MEMORANDUM

Our Ref: EP/DC/PP/2018/0854 **Your Ref:** MR/P/2018/0854

Location: O. S Grid Ref: 375 490 Scallywags Day Nursery, Bridge Road, Wrexham Industrial Estate, Wrexham.

Development: Demolition of existing Day Nursery and Outline Application for residential development for 7 no. dwelling units.

7.5t Panel Van	
Overall Length	7.210m
Overall Width	2.192m
Min Body Ground Clearance	0.316m
Track Width	1.865m
Lock to Lock Time	4.00s
Kerb to Kerb Turning Radius	7.400m

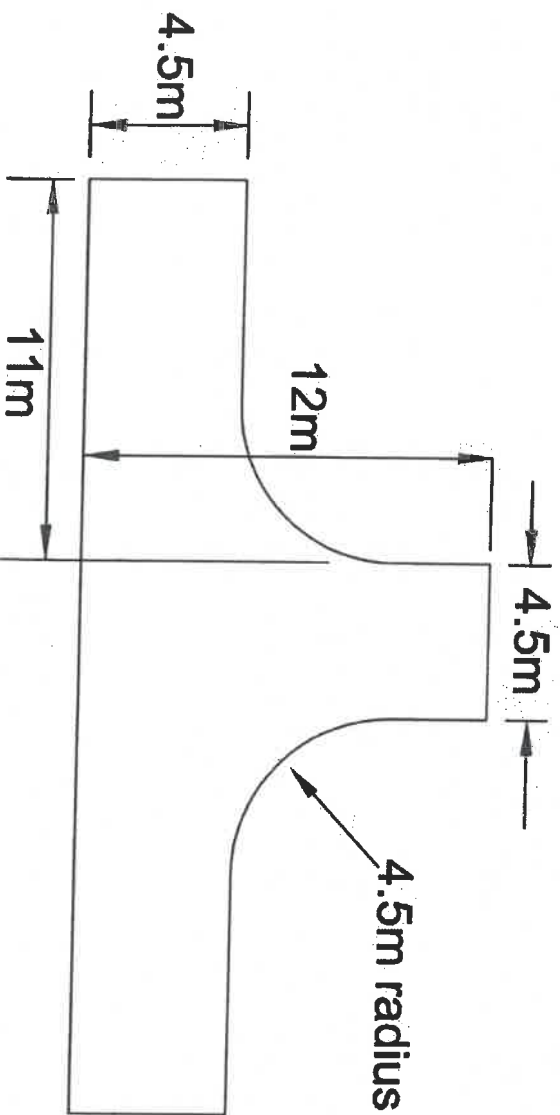
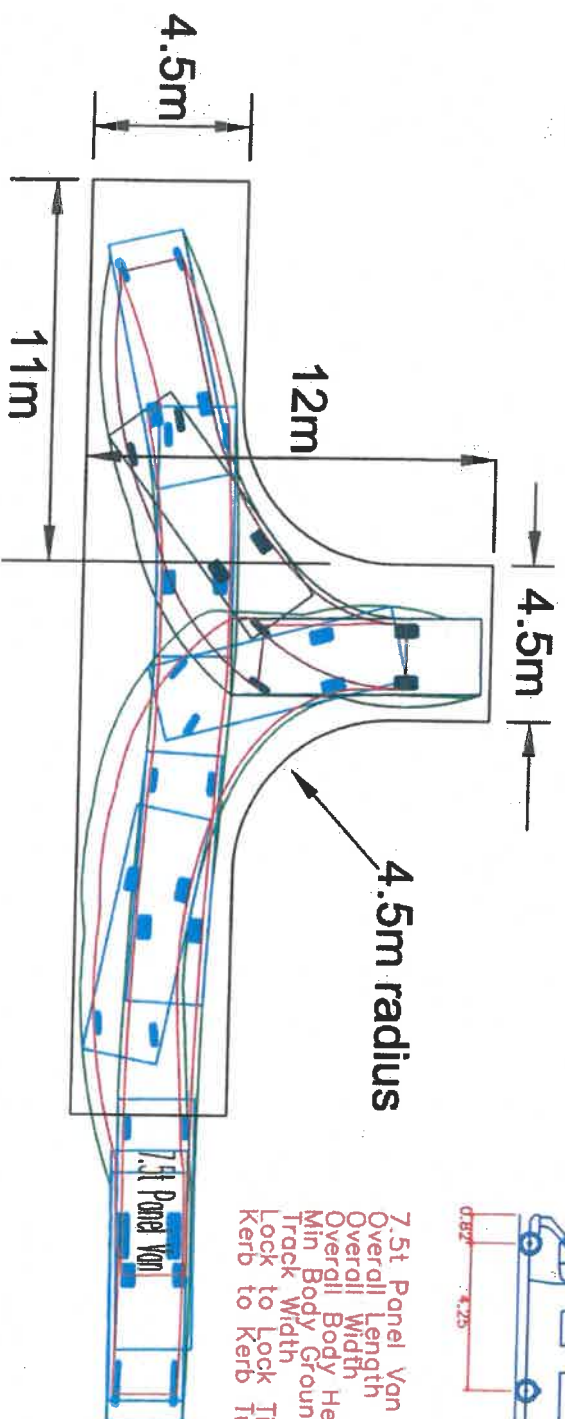
I would recommend that consideration is given to providing turning provision for a medium sized delivery vehicle (see attached detail). I understand that refuse vehicles currently struggle to access the site so typically reverse along this unadopted road off Bridge Road which is not ideal.

I would recommend that consideration is given to providing turning provision for a medium sized delivery vehicle within the curtilage of the site (see attached detail). I understand that refuse vehicles currently struggle to access the site so typically reverse along this unadopted road off Bridge Road which is not ideal.
